**Roosevelt Mixed-Use
University District, Seattle, Washington**

**Neighborhood
Early Design Guidance, September 23, 2013**

September 8th, 2008 EDG Meeting Minutes with current responses

Street level view - Current Option

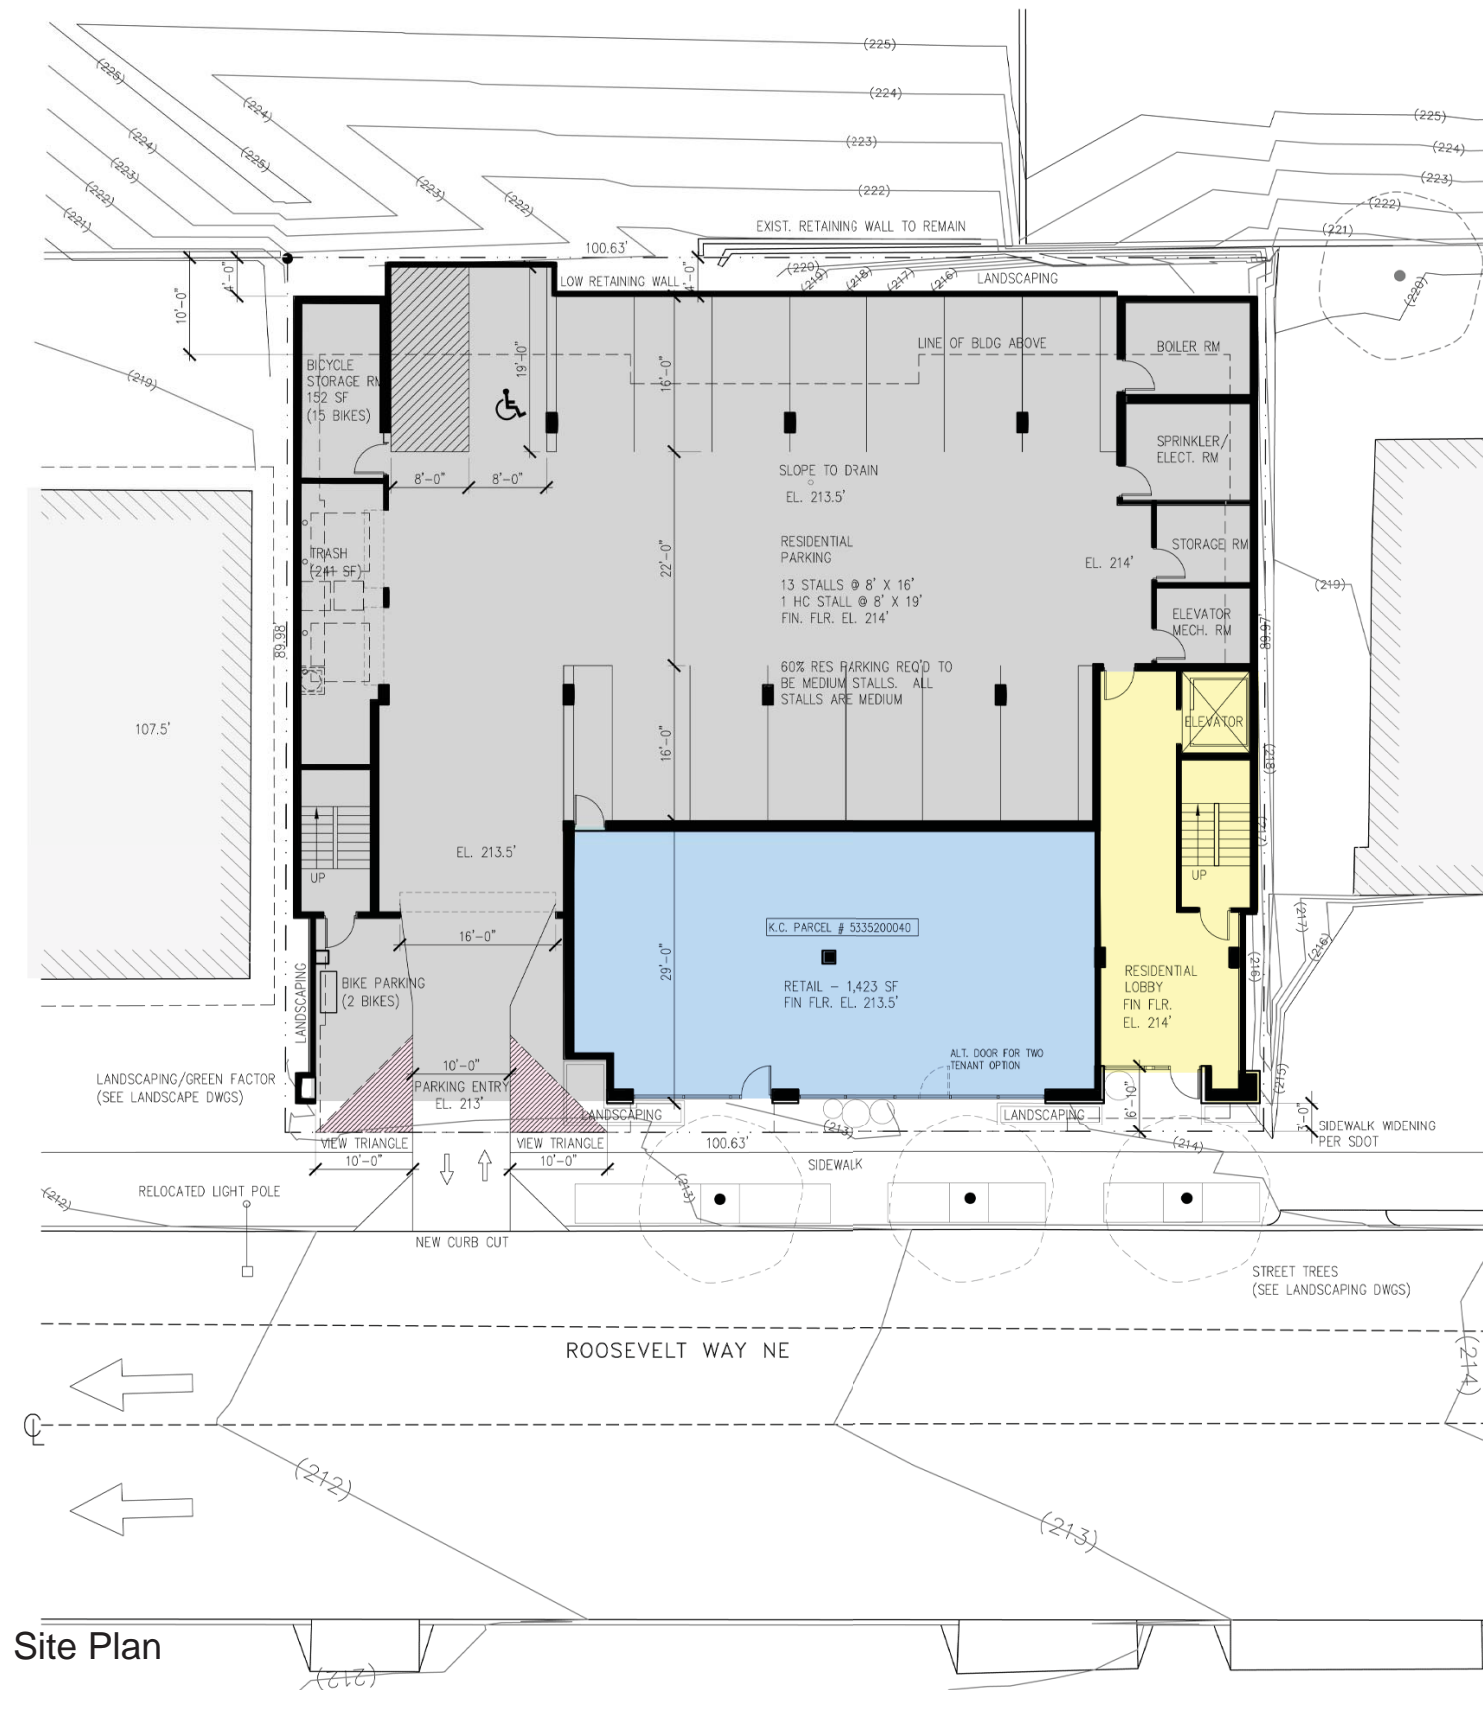
The Board suggests that the massing of the building remain simple and bold. The Applicant is encouraged to utilize a design that uses elements of rhythm and scale to break down the overall massing of the building but avoids "clutter" and unnecessary or excessive modulation. The Board suggests that other design options incorporate a reduction in the size of the building be explored instead of the proposed notch in the northeast corner of Option Three. The incorporation of "Juliette Balconies" would serve well to provide a detailed residential appearance, create a rhythm and limit appearance of building mass.

The Board suggests that the design of the residential floors of the building incorporate architectural features and elements that provide human scale to the residential units. Juliette balconies on some of the units are an example of Human Scale. First floor canopies along Roosevelt are requested. Continuous overhead weather protection should be provided along the sidewalk frontage. A design rationale for the base needs to be developed which incorporates the northeast corner in a meaningful way.

- Response - The design and architectural expression of the proposed building follows current examples of other projects in the neighborhood. This project uses similar building materials (Metal, brick & glass) found in surrounding projects. Following the boards recommendations, the overall building massing and modulation has remained simple. The east facade has been modulated similar to the west elevation to provide more architectural consistency. The parking entry will be setback to minimize its impact on the street. The large retail display windows face the street and open onto the sidewalk. The residential lobby is pushed back from the street to create a residential "porch" along the sidewalk. The setback reinforces the separation of the retail and residential entries.

- Response - Canopies along Roosevelt Way will be incorporated to provide shelter for pedestrians as well as create a separate identity for the retail and residential entry. The ground floor walls will incorporate either brick or colored concrete masonry to create a pedestrian friendly appearance. The upper floors will be modulated and balconies will be added to provide visual interest to the building.

After the last EDG presentation in September, 2008, the NE Design Review board recommended to proceed to the MUP and DRB process with option #3. Since then, the building design has evolved from option #3 to the current more developed and fully rendered option as shown above. These design changes were the result of recommendations made by the Design Review Board. These include modulating the west façade, adding brick at the street level, adding canopies over the storefronts and adding julliett balconies at the upper residential floors. The board also recommended that the future design refinements look at simplifying the building's massing by eliminating the "notch" at the NE building corner. The corner was filled in with additional windows. By adding windows at all four corners the scale of the building's north and south walls was reduced. The building evolved further as a result of market conditions. The total number of units changed from 70 units to 60 units as a result of enlarging the individual units.

Setback/Building Modulation Diagram - West Elevation

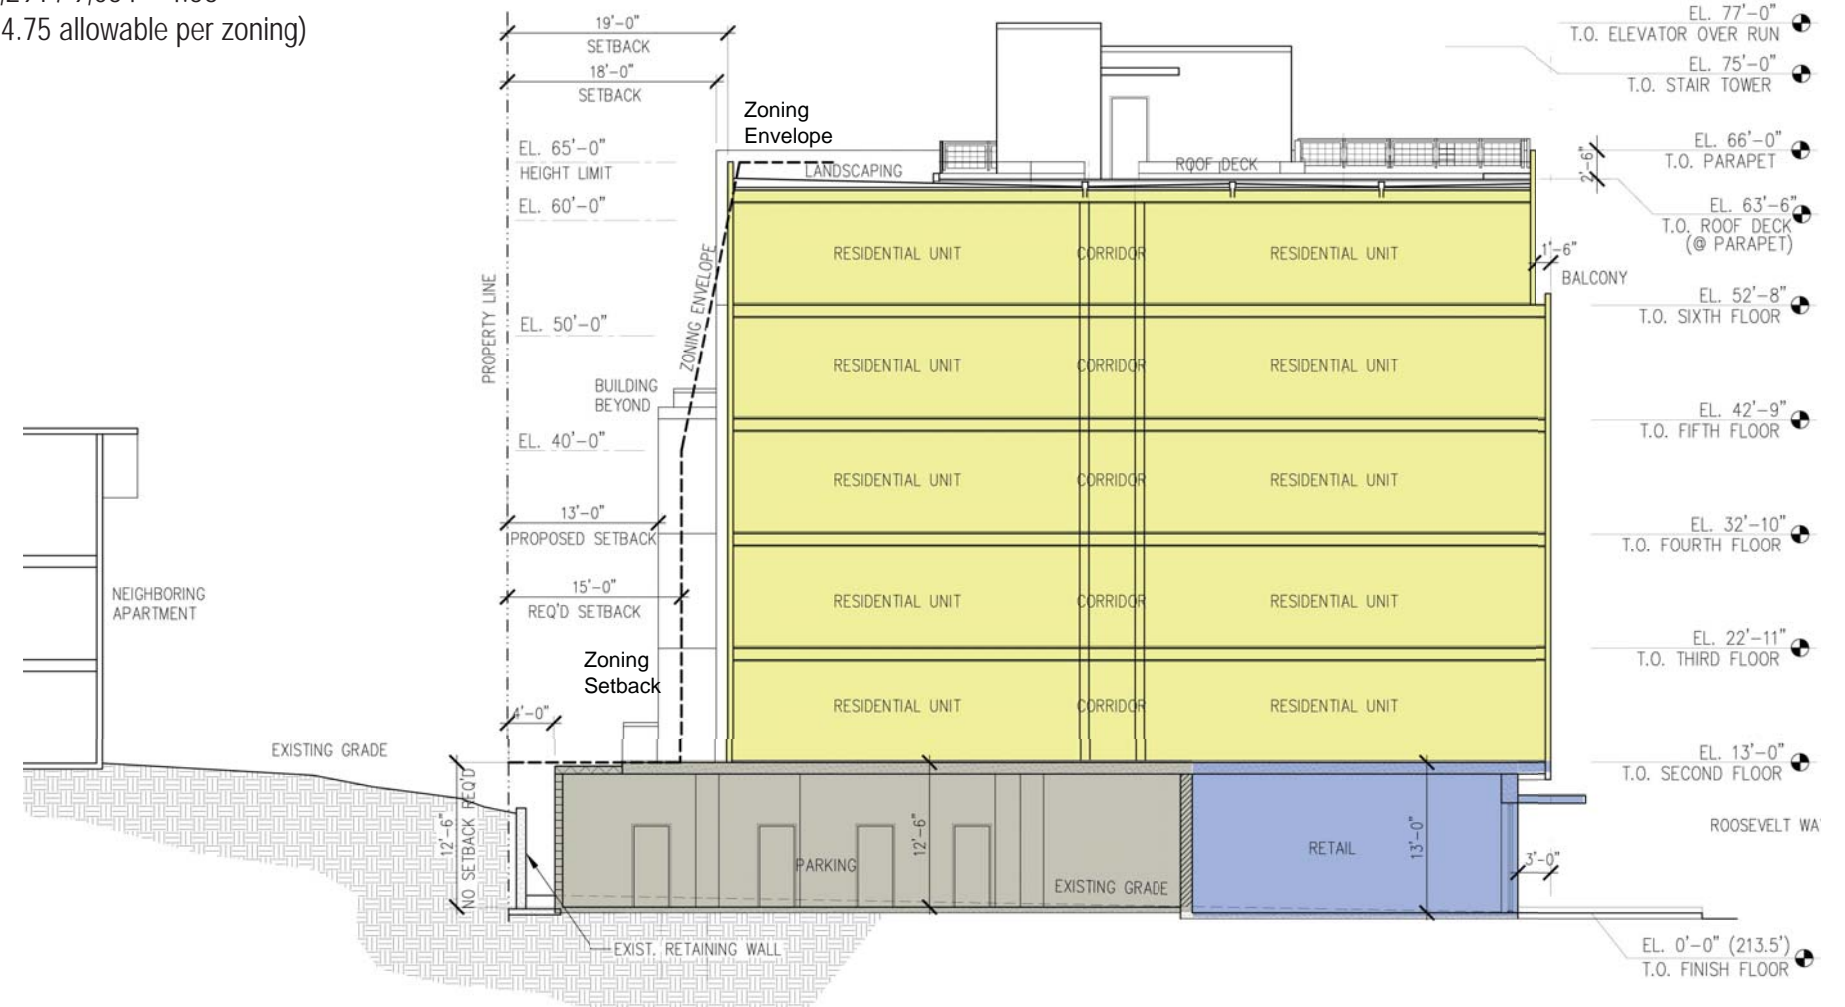
The west wall of the Project should provide a sensitive transition to the adjacent, less-intensive L-1 land use district. The setbacks on the west wall should meet the minimum code requirements unless building forms are designed in a manner which better addresses the height, bulk and scale relationship to properties to the west than a code complying approach would. An example of such an approach would be a two to three foot encroachment into the setback at the lower levels being mitigated by a two to three foot additional setback at the upper levels. Presentation materials at the next meeting should show surrounding buildings.

- Response - The lower floors encroach 2' into the required 15' setback. This has been mitigated by stepping the upper floors (Fifth & Sixth) back an additional 6' (2' to 4' more than is required). Additional reduction in building massing has been made by moving the north & south perimeter walls approximately 3' away from the neighboring property lines.

To follow the N.E. DRB's recommendations to modulate the west elevation, the N.W. and S.W. corners encroach into the 15' setback by 2'. However, due to the overall modulation of the west elevation, the average setback is 16.2'. We are requesting to average the setback along the west property line (see averaging diagram p#26) per Early Design Guidance meeting comments (9/8/08).
